Erratum

Corrections to "Accurate Distributed Inductance of Spiral Resonators"

Z. M. Hejazi, P. S. Excell, and Z. Jiang

Fig. 1. Segment pair combinations contributing to any spiral configuration and their common equivalent circuit. The arrows indicate the current direction and θ is the segment resolution.

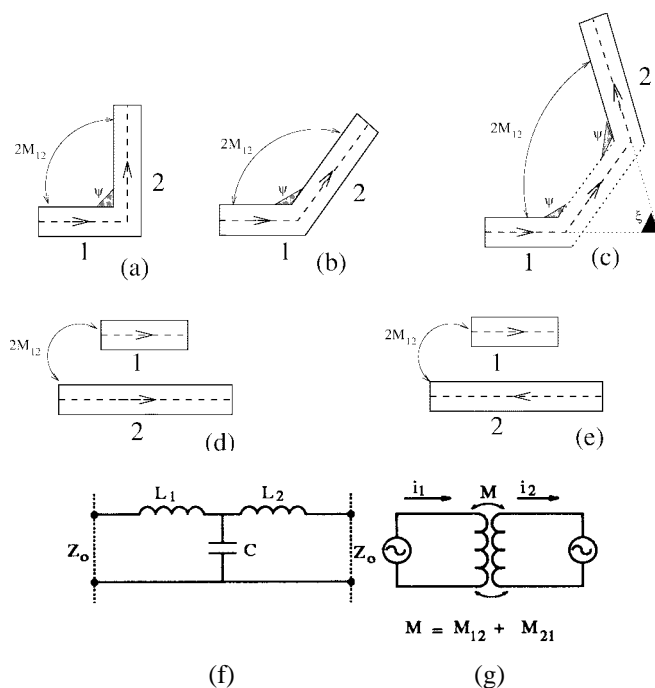
In the above letter,[1] the sentence beginning on the third line following equation (1) on p. 165 should read "The last term is positive when $\xi < 90°$ [see Fig. 1(c)] and equals zero when $\xi = 90°$." Also, due to a production error, Fig. 1(f) and (g) was omitted. The complete figure is shown here.
